Browns Summit Creek Restoration Project Year 1 Monitoring Report

DMS Project ID No. 96313, DEQ Contract No. 5792

Subject: Response to Task 7 Draft Year 1 Monitoring Report Comments dated January 2, 2018
Browns Summit Creek Mitigation Project, Guilford County
Cape Fear Cataloging Unit 03030002
USACE AID SAW 2014-01642, CMS Project #96313

Figure 7 Wetland Restoration Graphs (2017)

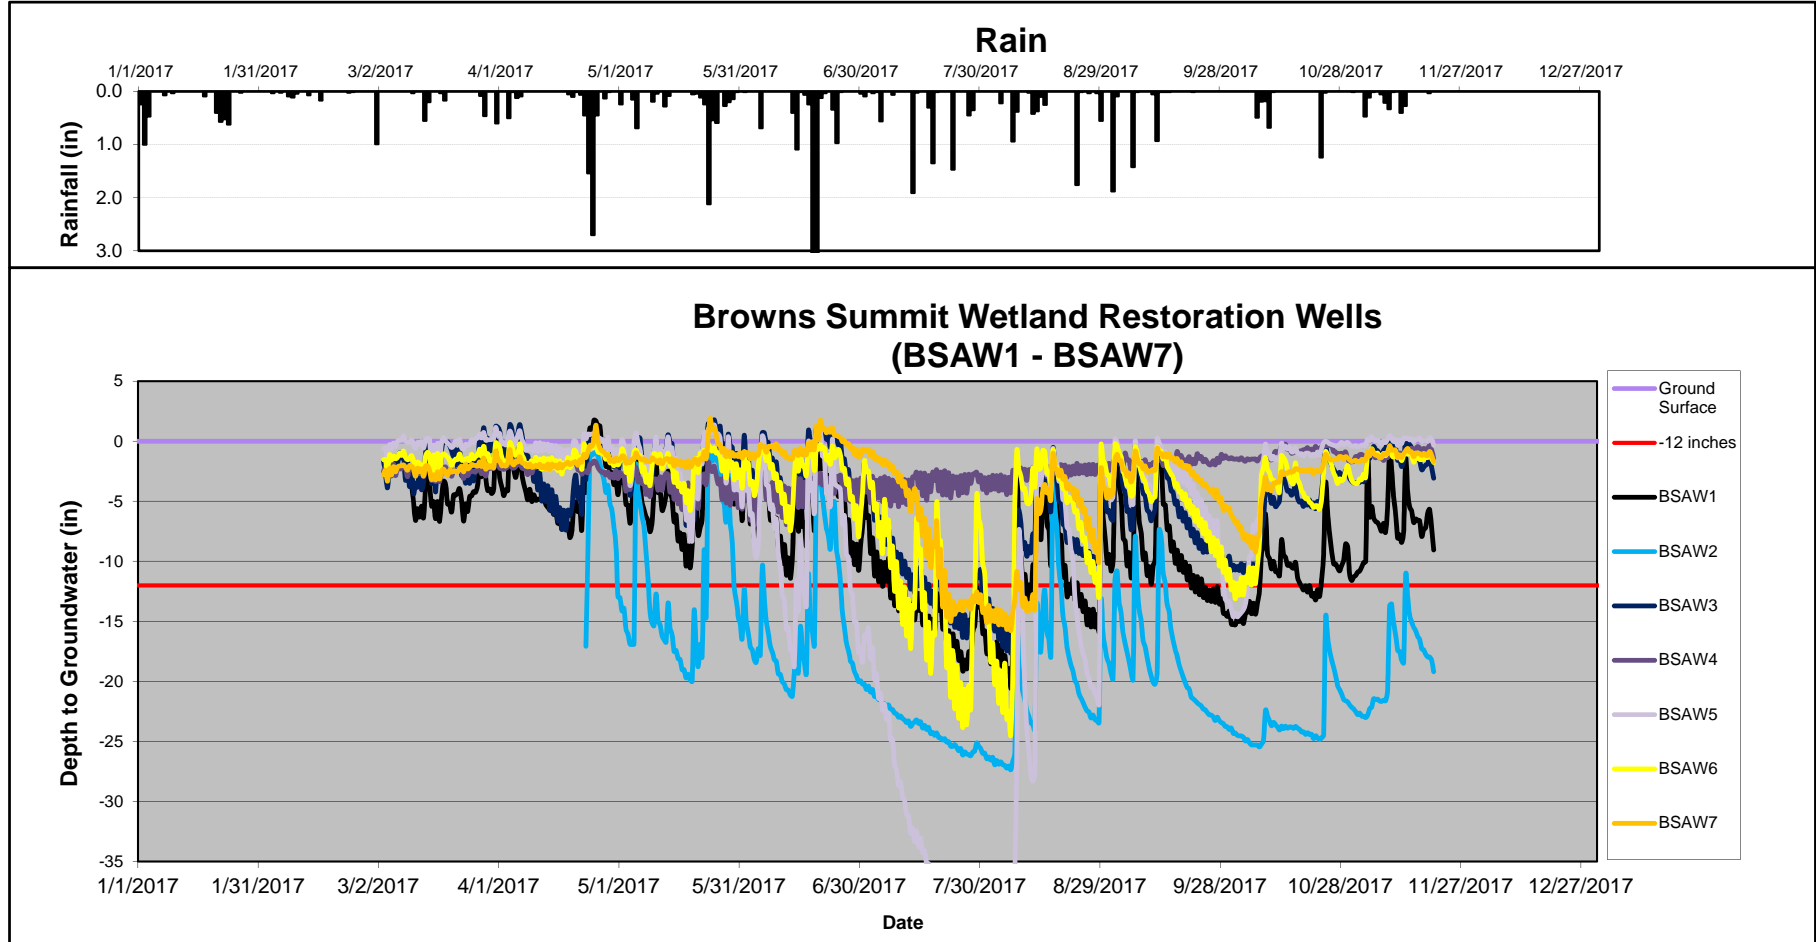
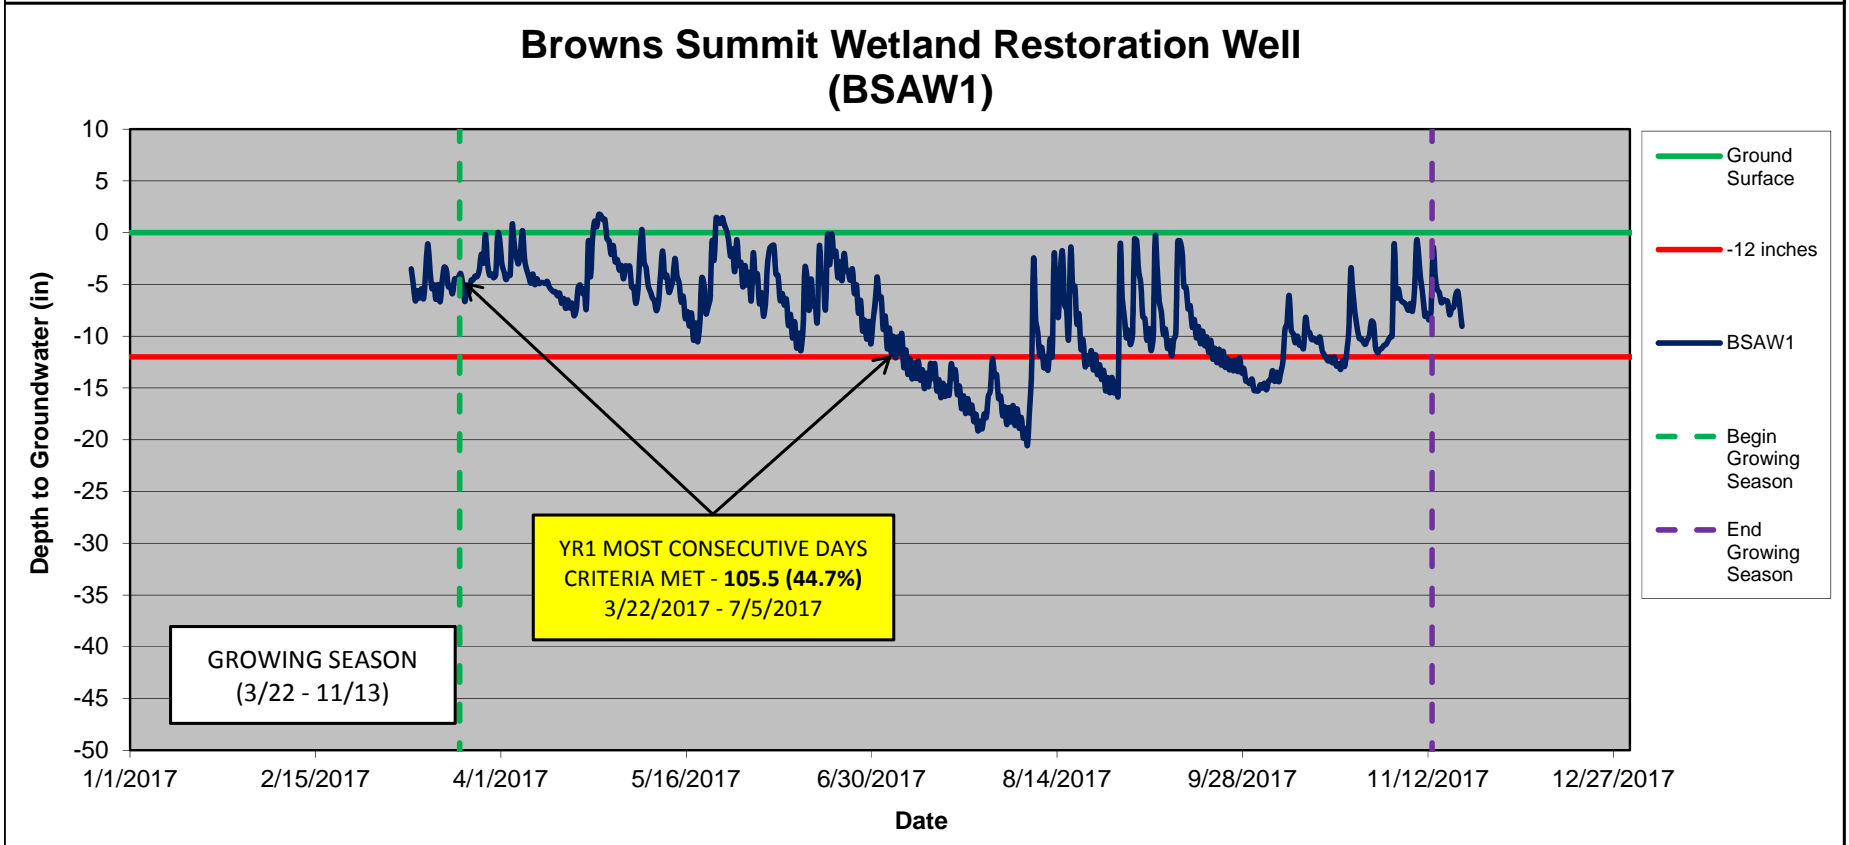
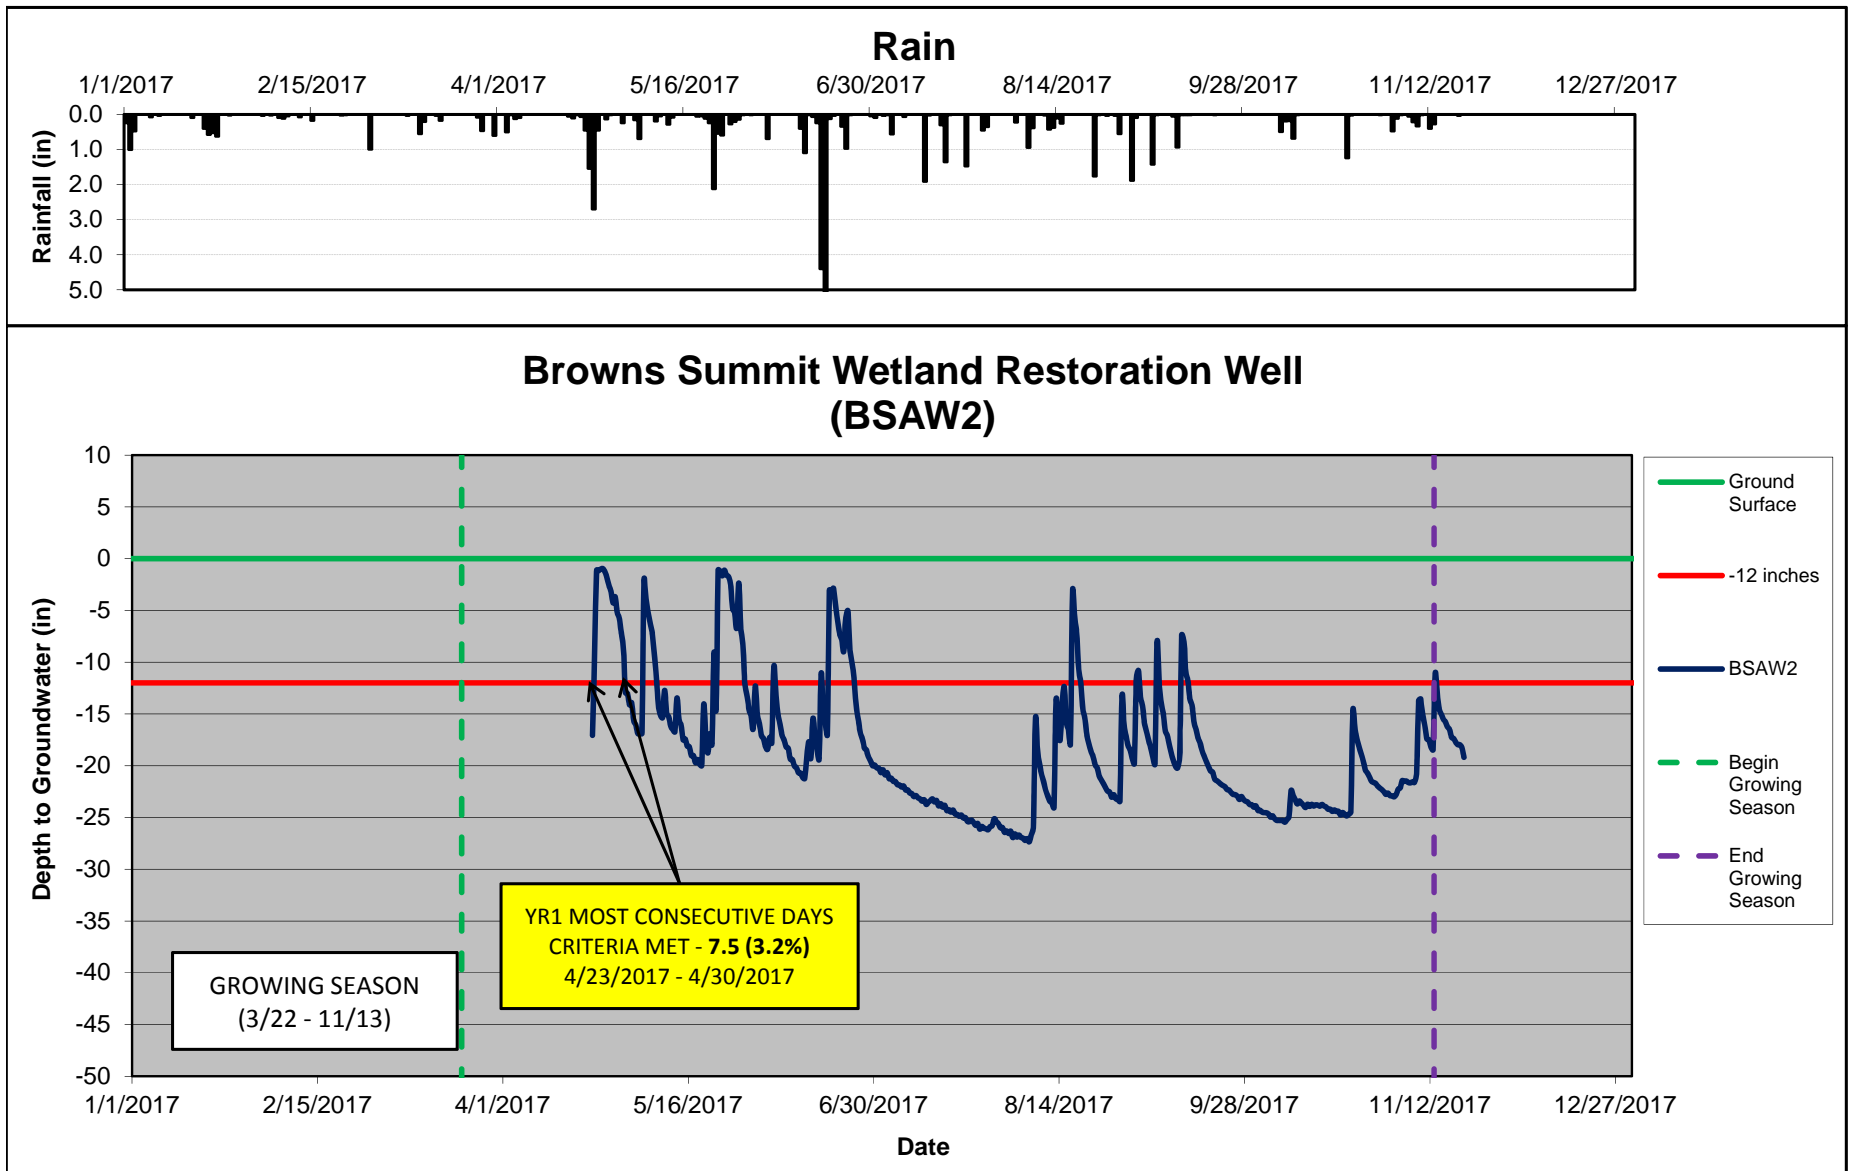
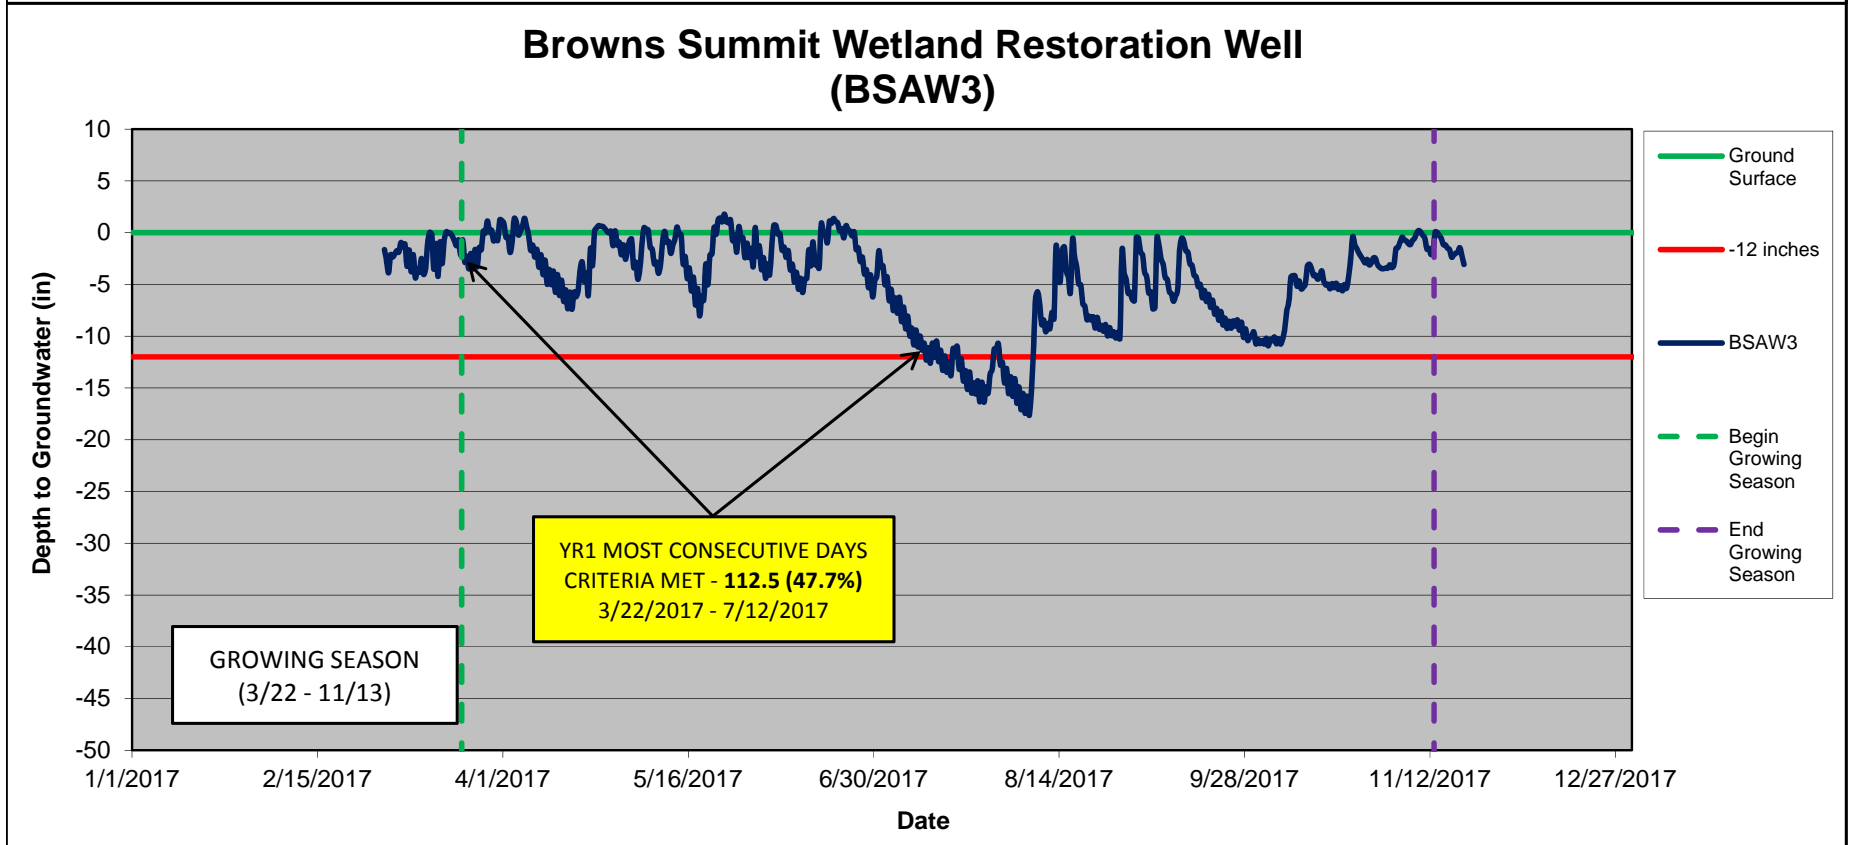
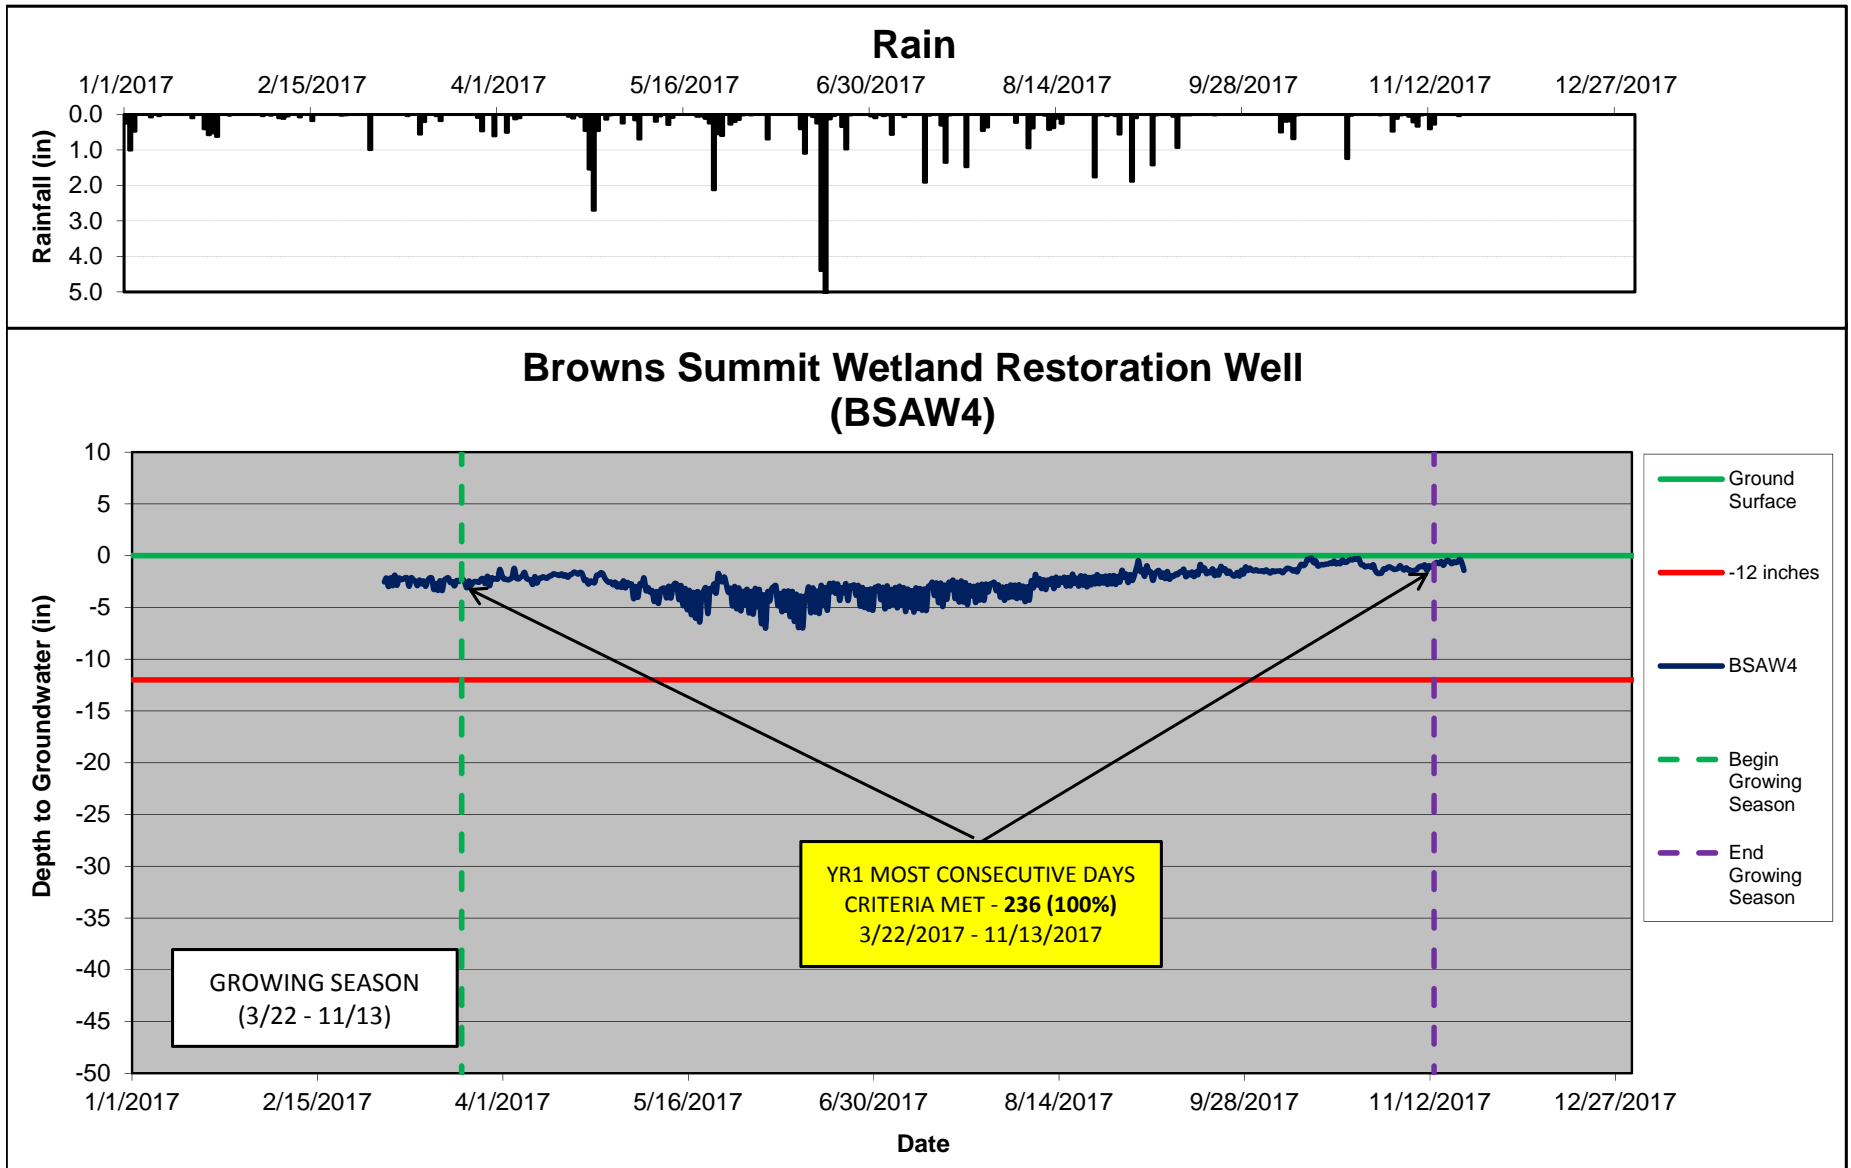
2. Section 1, page 2: Explain why there was a month gap in data for gauge BSAW2 during the monitoring period.

Response: The automated collector was not acquiring data properly, upon re-inspection approximately one month into the monitoring season, the logger was re-set and began acquiring data.
